Proposed resolution for comment #253, #298 on FTS and PTS

Nader Zein, Takatoshi Ogawa and
S. (Ram) Ramanan
NEC

Date: 2019-01-15

Example of TimeError budgeting for 5G MFH (NGFI-I)

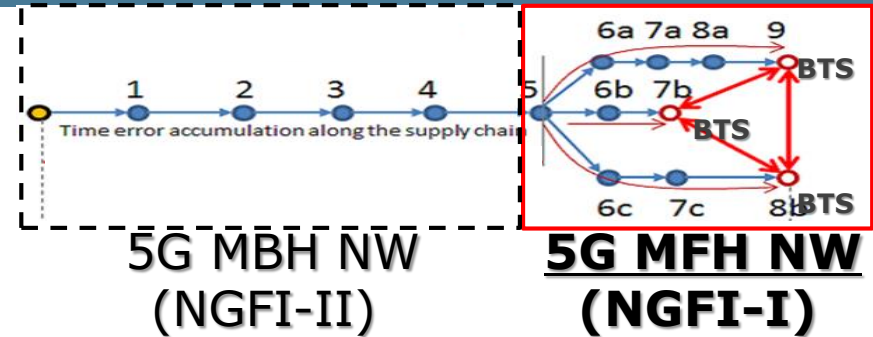
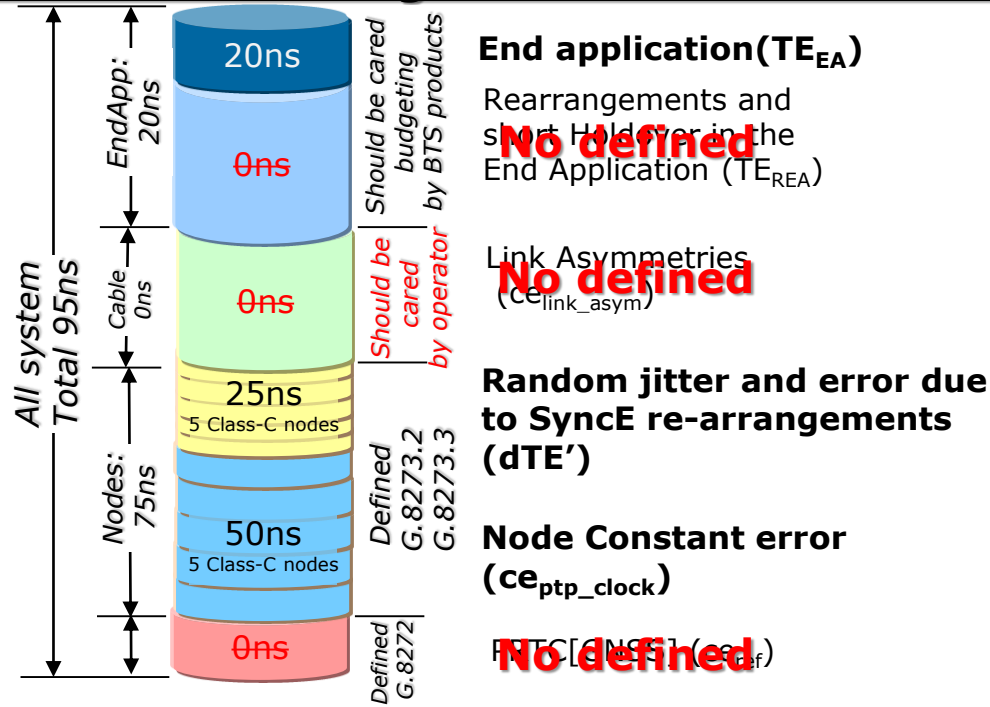
5G MFH has requirement of $\max|TE_r|$.
 Example of budgeting is shown below;

- This examples are based on IEEE802.1CM-2018 and ITU-T G.8271.1(FTS).
- This case is not entered the End Application to holdover(because not using GNSS, and only using wire line).

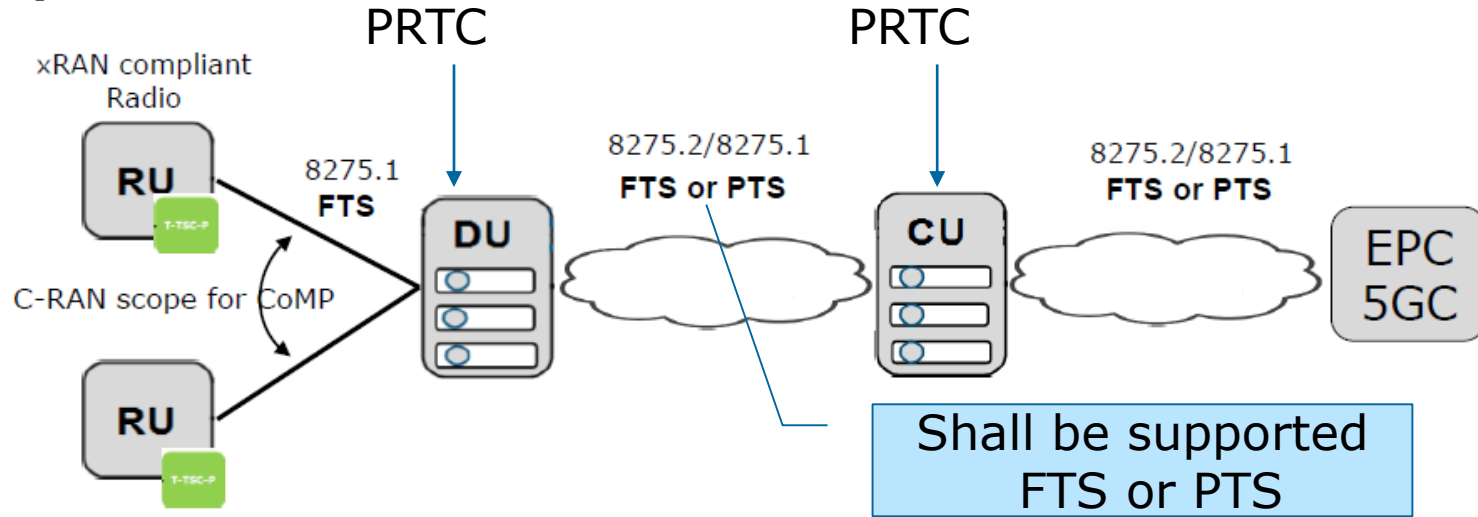
Case (1): Requirement for Fronthaul (NGFI-I) and midhaul (NGFI-II) ~~should~~ could be specified separately, considering differences in network topology, transport distance, and timing requirement, **if separate PRTC is supplied for the NGFI-I network.**

- For NGFI-I (fronthaul), ITU-T G.8275.1 (FTS) is mandatory while ITU-T G.8275.2 (PTS) is optional,
- For NGFI-II (midhaul), the standard specifies the requirement as it is today (either G.8275.1 or G.8275.2 shall be supported)

Case (2): In case the PRTC for the NGFI-I (fronthaul) is supplied via the NGFI-II (midhaul) Chain as shown in slide#7, then ITU-T G.8275.1 (FTS) should be used as mandatory for both NGFI-I and NGFI-II, ITU-T G8275.2 (PTS) is optional for both.
